Grafton & Upton Railroad Company

Re: 2nd Response to RFI Regarding 364 West Street, Hopedale Massachusetts
NPDES ID MAR1002EB - Construction General Permit (CGP)

Re: Request for Information Regarding 364 West Street in Hopedale Massachusetts

SWPP - PLAN

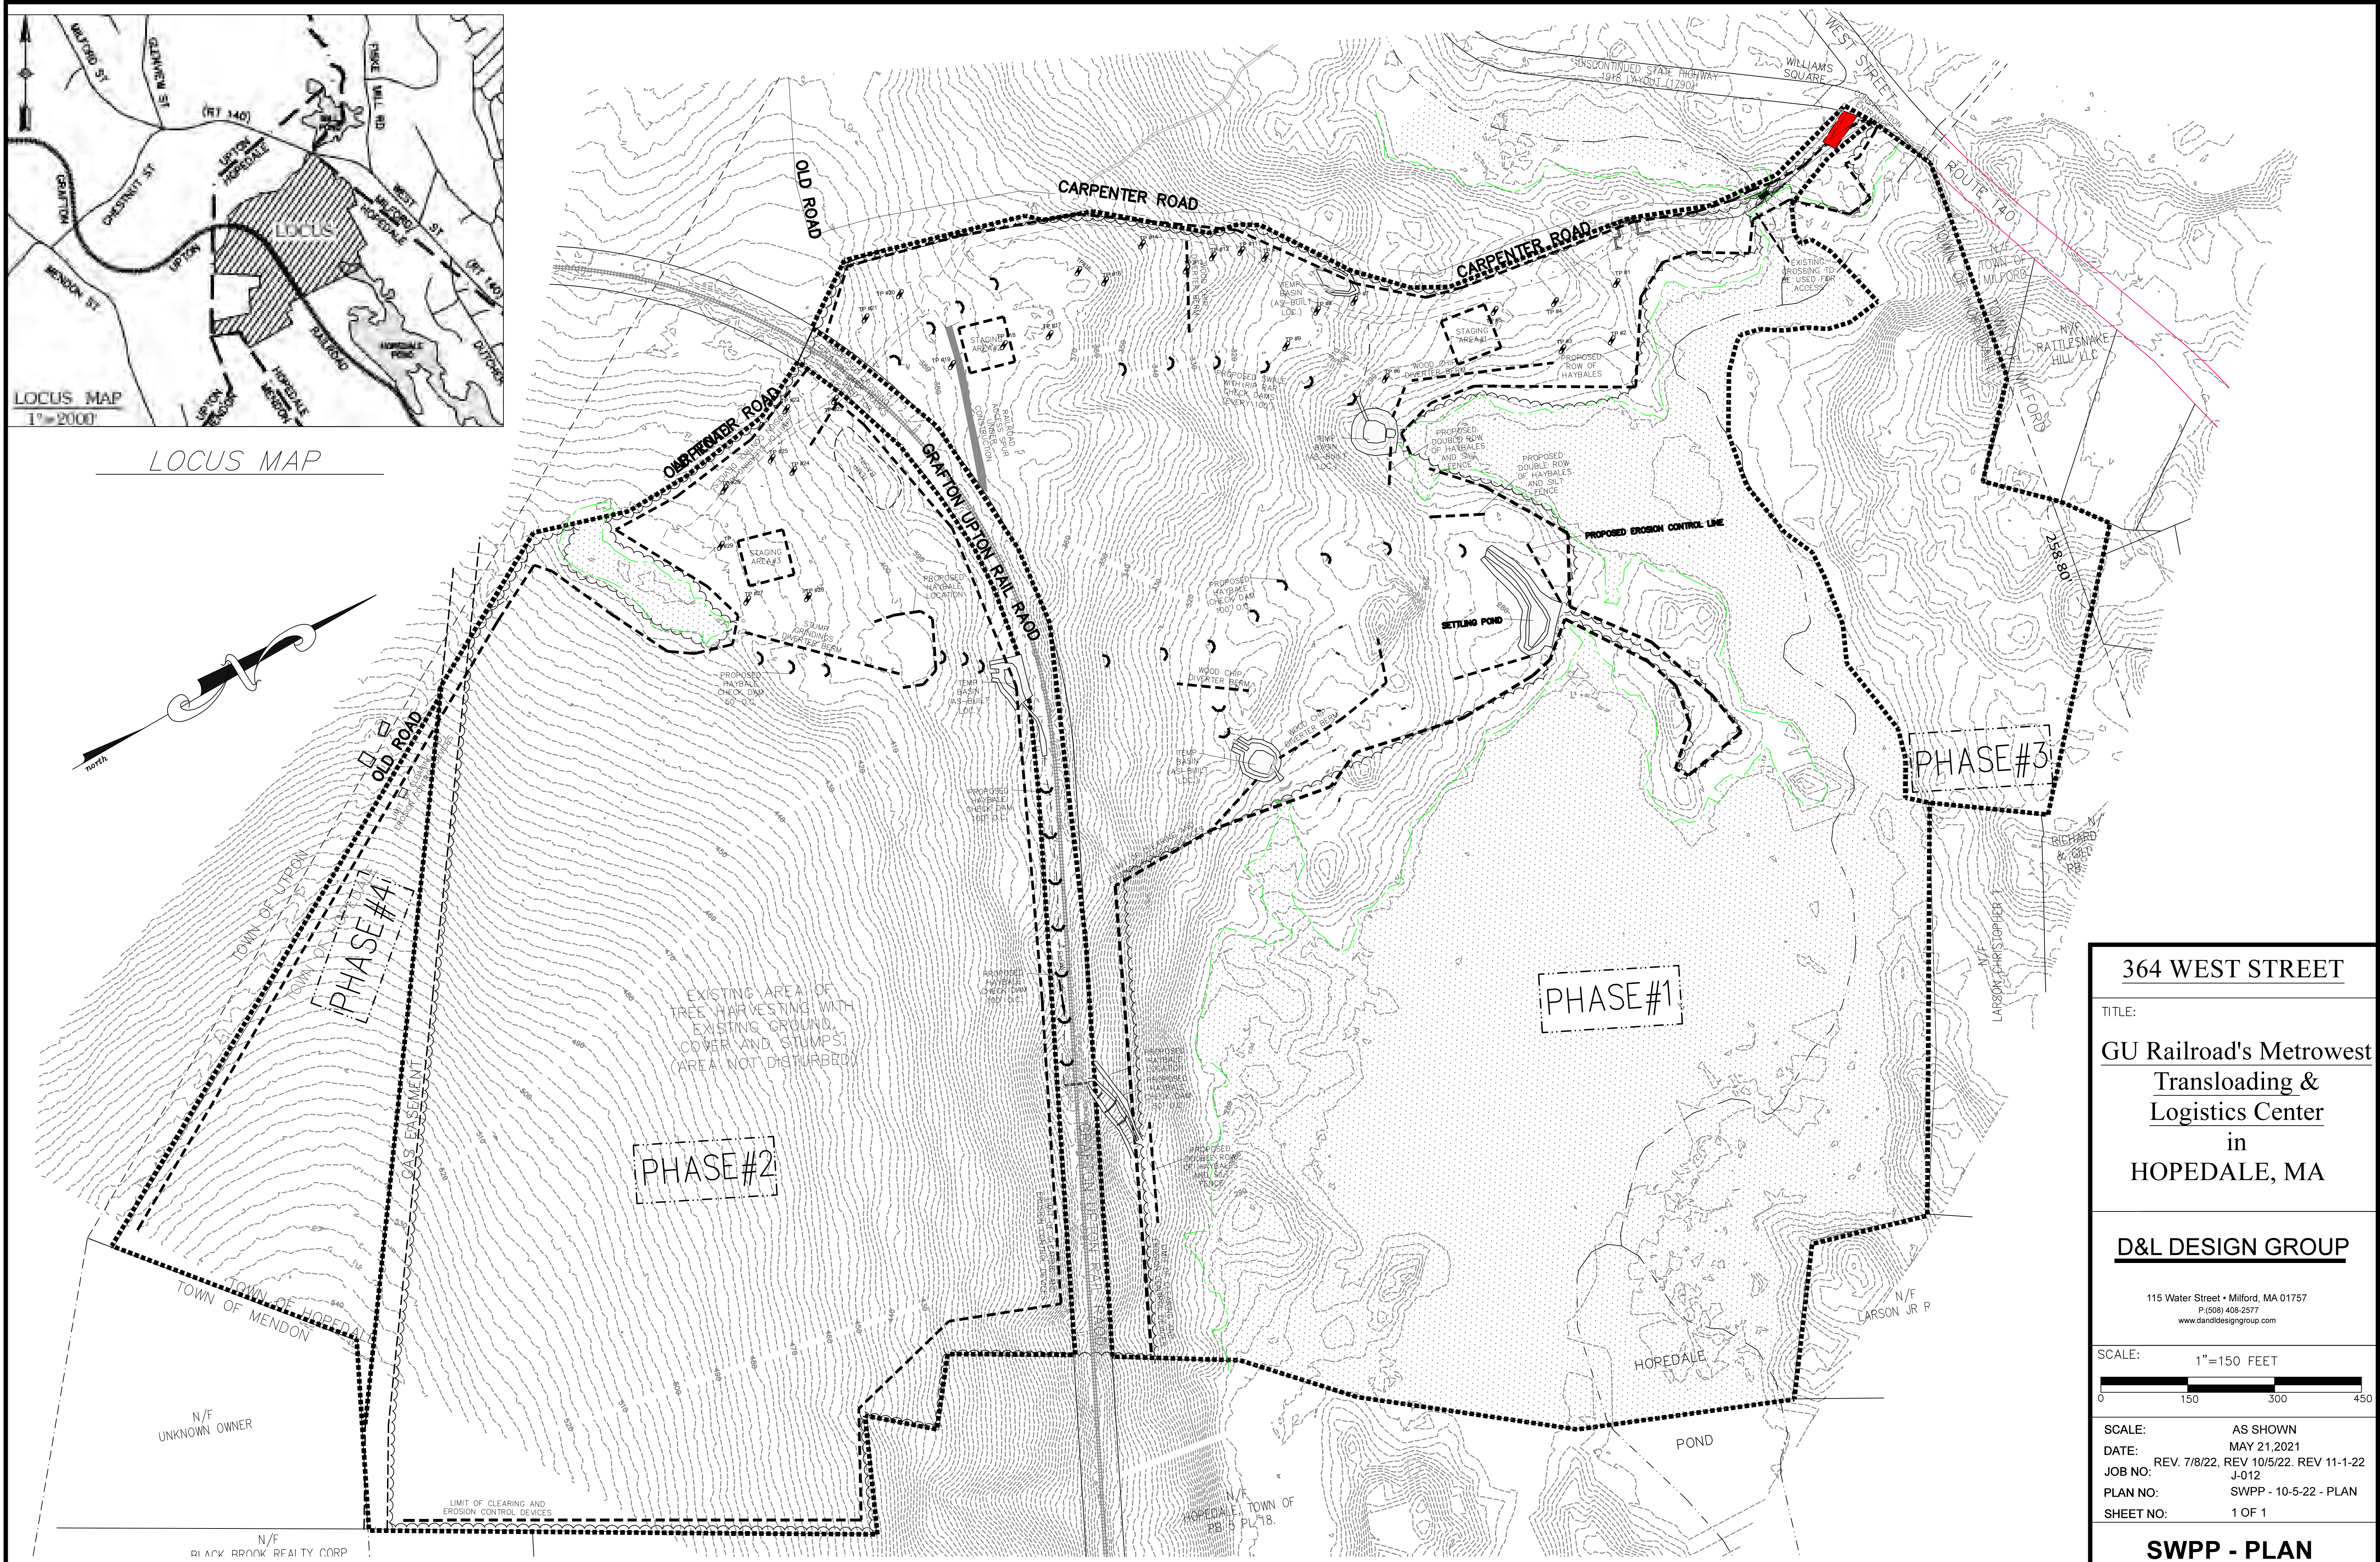
- **The new deadline to submit the 2nd response to requested information was extended to November 7, 2022.**
1. *Your facility's National Pollutant Discharge Elimination System (NPDES) Construction General Permit (CGP) Stormwater Pollution Prevention Plan (SWPPP) for NPDES ID MAR1002EB*

4. *All calculations conducted demonstrating that sediment basins used for stormwater control during construction meet the sizing requirements of 2.2.12.c of the CGP*

- **SWPP has been updated showing the temporary sedimentation basins, designed to handle the two-year storm event after timber harvesting, no development and construction activities have begun at site, see attachment (Exhibit A).**

- **Temporary sedimentation basins have been designed, modified, and constructed to capture the two-year storm event of the current, existing conditions (see Exhibit A). The temporary sedimentation basins associated with the drainage / run off from the gravel haul road has been sized appropriately using higher "curve" numbers. These temporary sedimentation basins are temporary in nature and will either**

be expanded upon or relocated during the final design phase of the project. The final sedimentation basins to be used during construction, will be designed, and incorporated into the overall larger detention basins, which will be sized to handle, at the minimum, the two-year storm event. During construction, the site will have more runoff and higher volumes to mitigate. Mitigation will be through the final designing of the drainage system, incorporating Low Impact Design (LID's) aspects and all basins (both temporary and permanent) will be design and sized in accordance with 2.2.12.c of the CGP.

Rail Development Plan

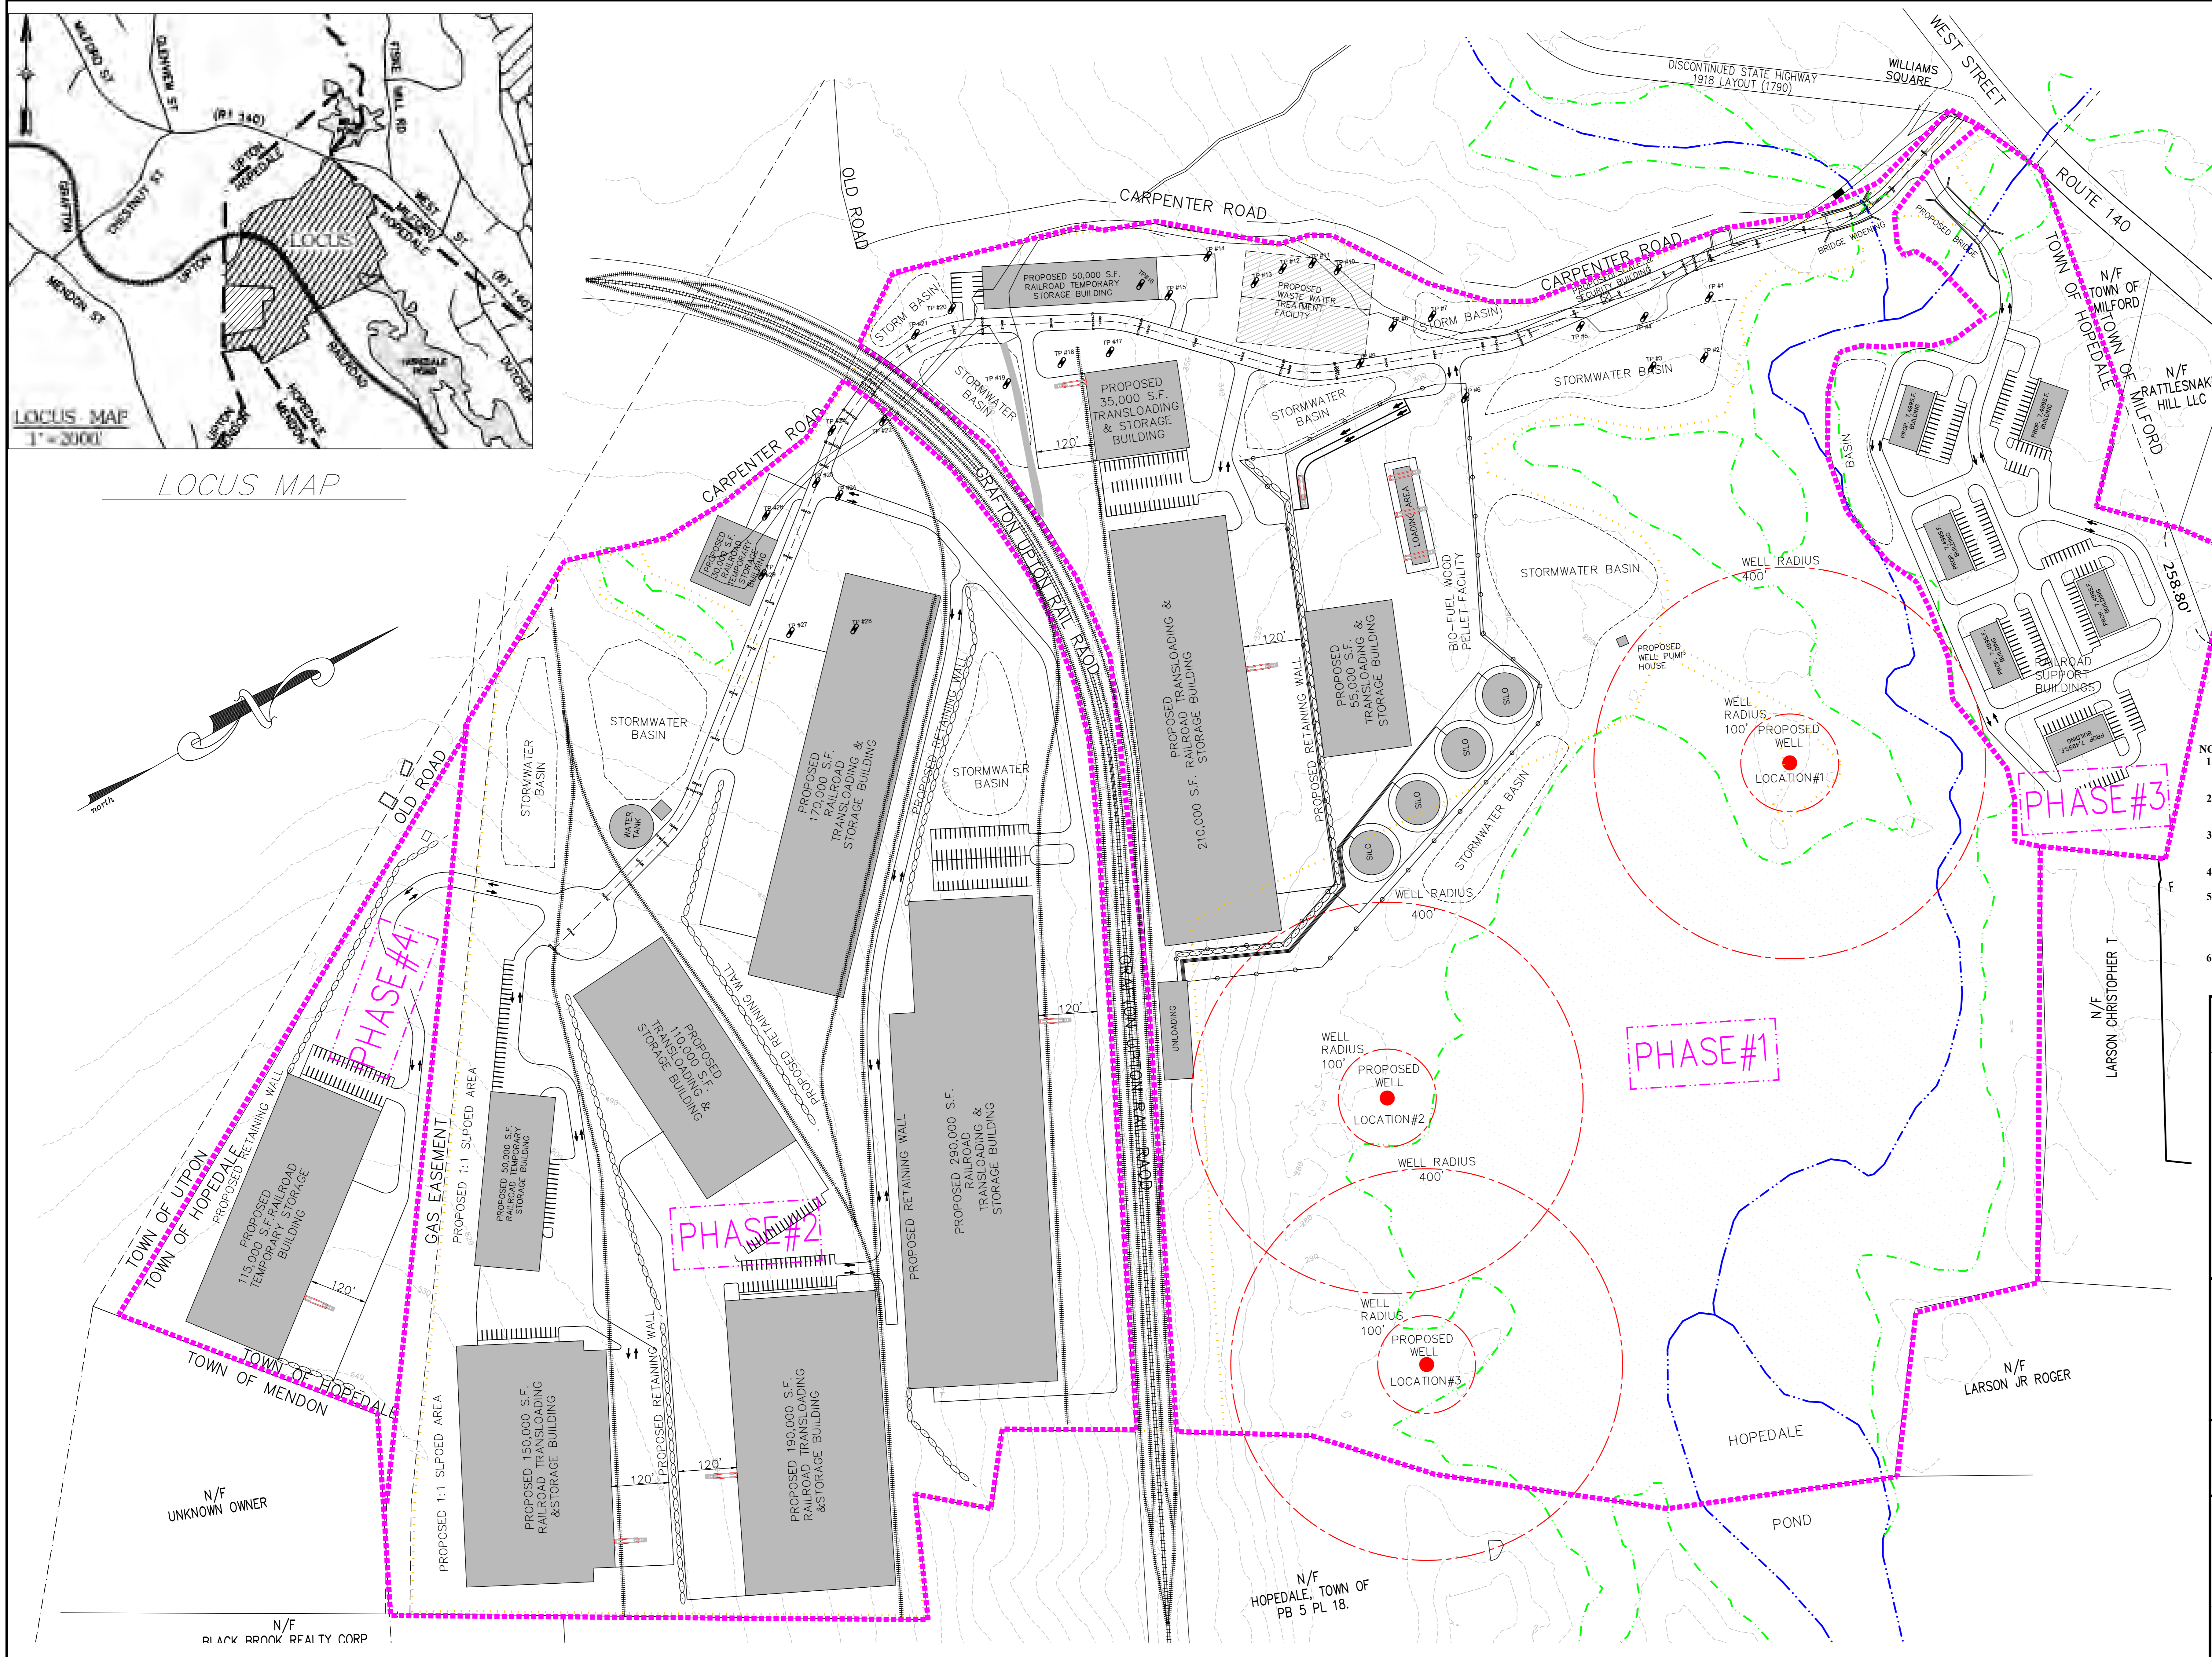
5. *Planned final site design maps, drawings, and other documentation that includes the following information:*
 - a. *Extent of area in acres of tree removal planned and extent of tree removal conducted to date*

- d. *Planned building footprints in square feet and associated activity for each building*
 - **Per the Transloading & Logistics Site Plan, the proposed building footprint areas are as follows (in square footage): Phase I = 418,176 SF (9.6 Ac.), Phase II = 988,812 SF (22.7 Ac.), Phase III = 43,560 SF (1.0 Ac.), Phase IV = 113,256 SF (2.6 Ac.), for a total of approximately 1,563,804 SF (35.9 Ac.)**

- **Site has undergone tree harvesting, to date there has been approximately 100 Acres harvested with an additional 20 Acres to be harvested in the future when site infrastructure and construction begins. See Exhibit A, SWPP Plan and Exhibit C, Transloading & Logistics Site Plan.**

- **Per the Transloading & Logistics Site Plan, the proposed impervious areas (including buildings) are as follows (in square feet): Phase I = 853,776 SF (19.6 Ac.), Phase II = 1,690,128 SF (38.8 Ac.), Phase III = 291,853 SF (6.7 Ac.), Phase IV = 213,444 SF (4.9 Ac.) for a total of approximately 3,049,200 SF (70 Acres) of impervious surfaces, of which 1,563,804 SF (35.9 Ac.) are roof tops.**
